**re: Grading, Servicing and Landscape Plan Review**  
Proposed Commercial Building  
30 Auriga Drive - Ottawa, Ontario

**file:** PG6513-MEMO.01

## Insulation for Site Services with Insufficient Soil Cover

Drawing Title: **SITE SERVICING PLAN**

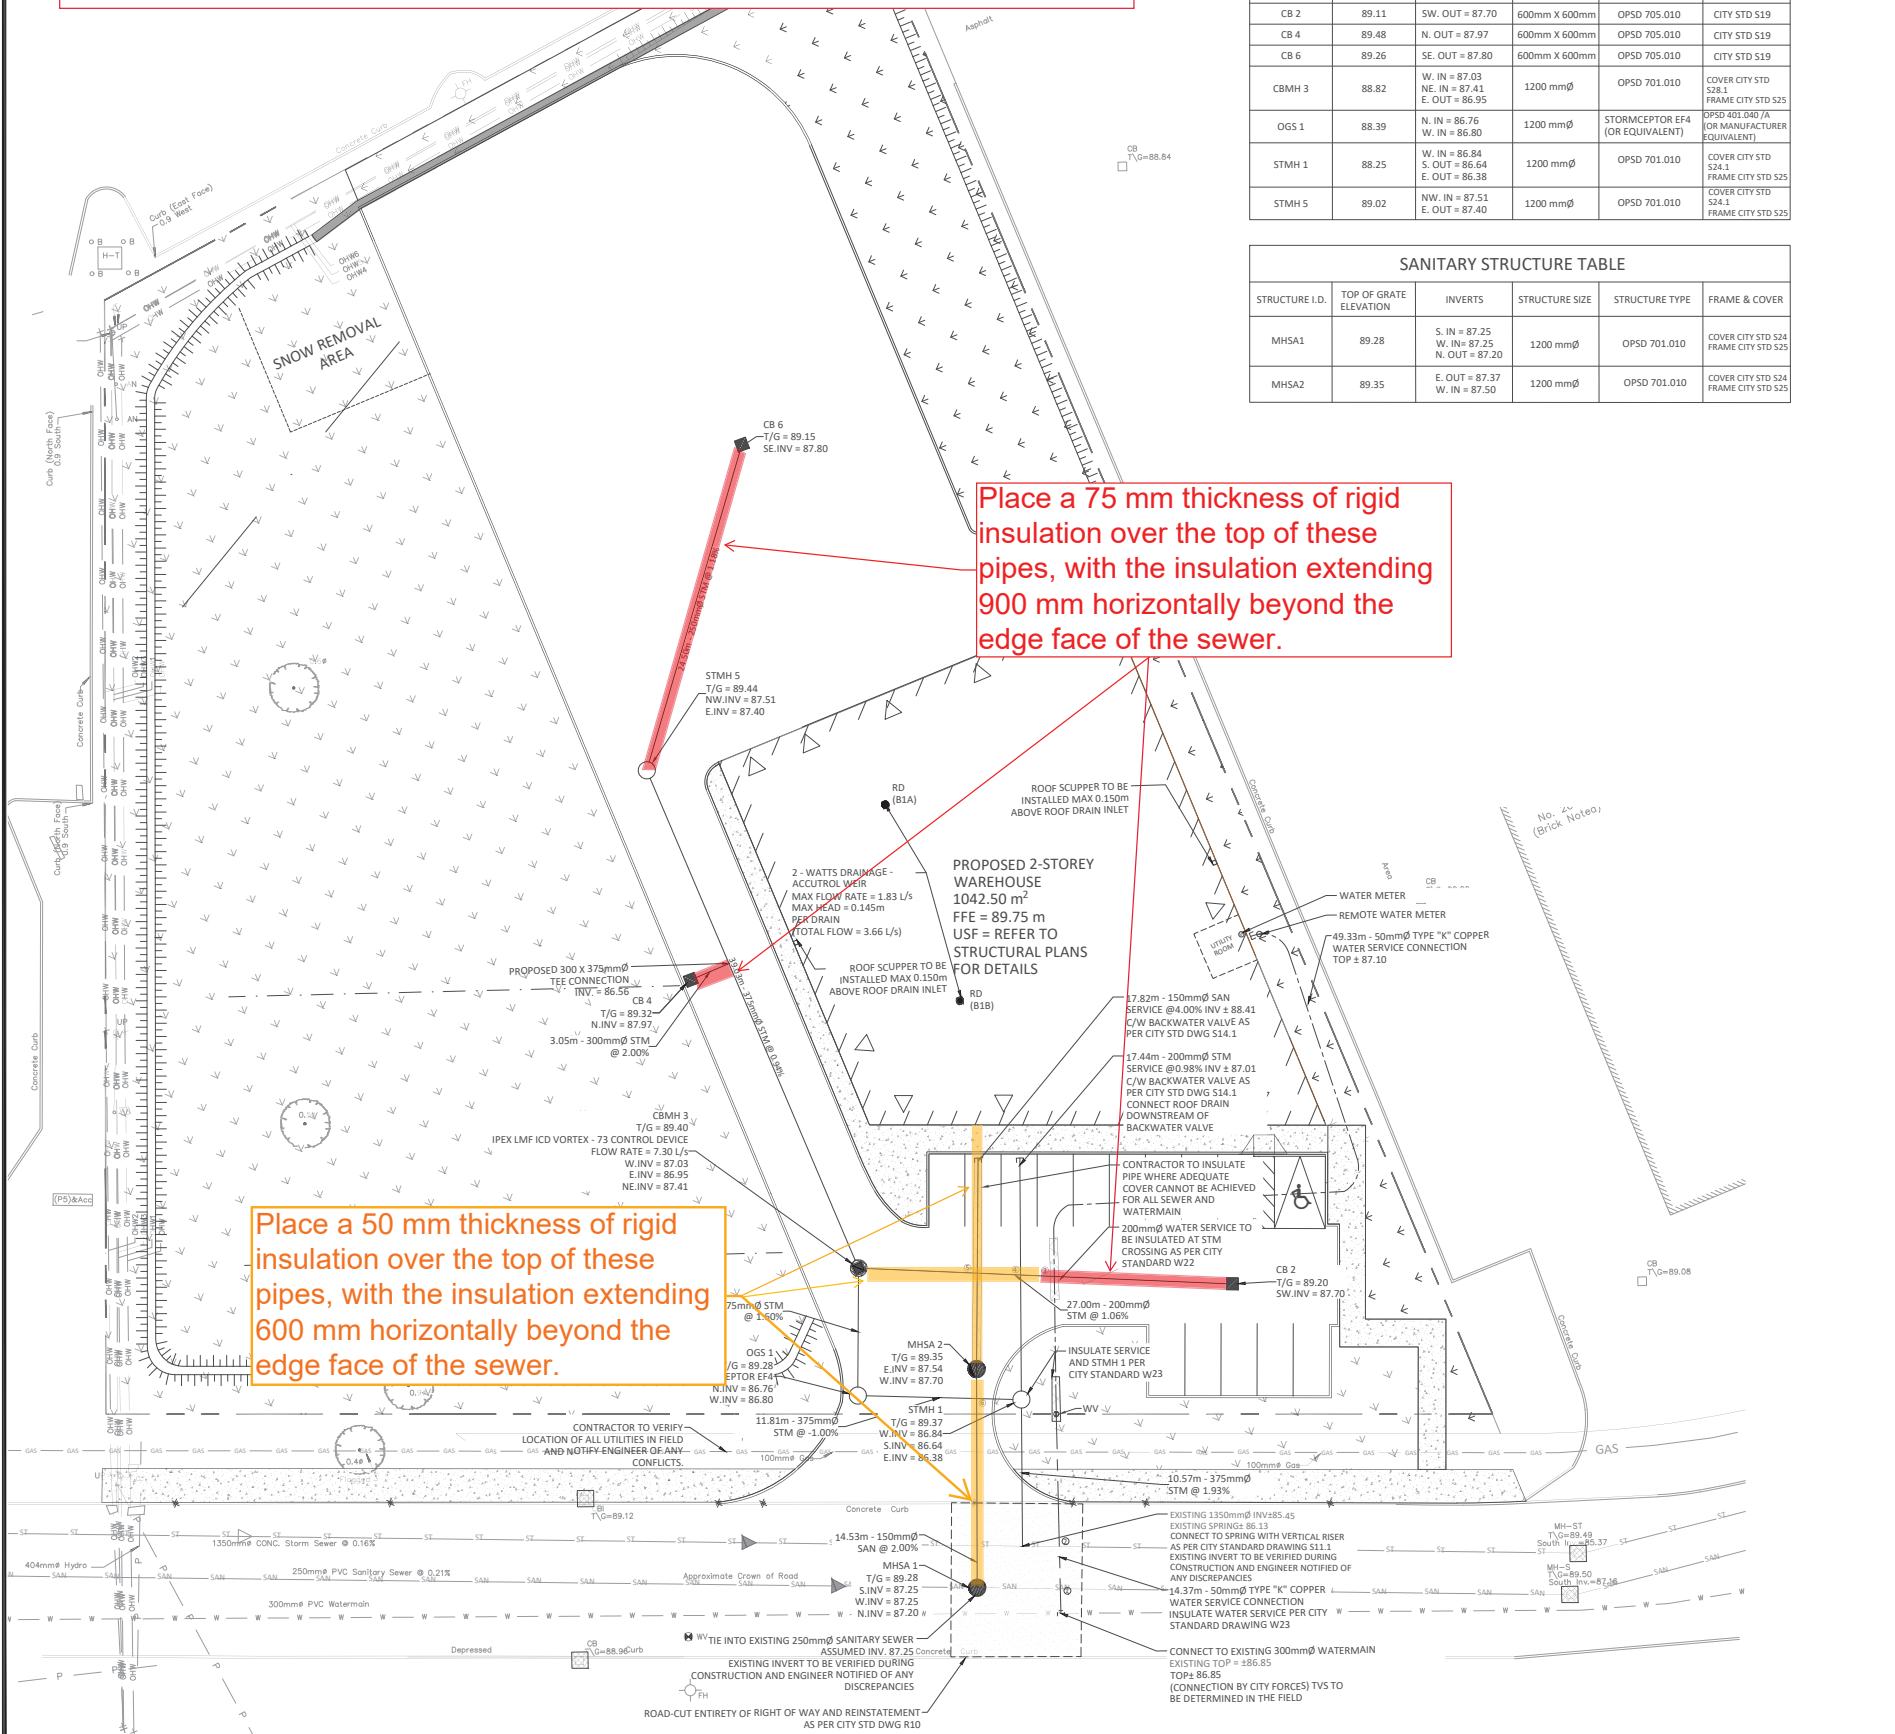
In reviewing the Site Servicing Plan, referenced above, most of the proposed services have sufficient frost cover. However, insufficient frost protection has been provided to certain storm services, where highlighted on the attached plan. Insulation of the site servicing is recommended where insufficient frost cover has been provided. Our detailed frost protection recommendations are provided below and on the attached plan.

Any portion of the proposed sewer services installed at a depth of 2.1 m below finished grade, or deeper, is considered to have sufficient soil cover for frost protection. However, based on our review, some of the proposed storm services and their subgrades are anticipated to be founded within the frost zone. Where insufficient soil cover is present above the obvert of the pipe, the following frost protection criteria should be followed:

Place a 50 mm thickness of rigid insulation over the top of these pipes, with the insulation extending 600 mm horizontally beyond the edge face of the sewer.

Place a 75 mm thickness of rigid insulation over the top of these pipes, with the insulation extending 900 mm horizontally beyond the edge face of the sewer.

Thermal Condition	Soil Cover Provided D (mm)	Insulation Dimensions (mm)	
		t (thickness)	L (extension)
Unheated	Less than 1,100	Not Recommended	
	1,100 to 1,400	75	Extend 900 mm horizontally beyond edge face of the sewer
	1,400 to 1,700	50	Extend 600 mm horizontally beyond edge face of the sewer
	1,700 to 2,000	25	Extend 300 mm horizontally beyond edge face of the sewer

All rigid insulation should consist of either Dow Chemical High-Load 40 (HI-40), Styro Rail SR.P400, or equivalent approved by Paterson. The placement of all insulation within the service trenches must be reviewed and approved by Paterson personnel at the time of construction.
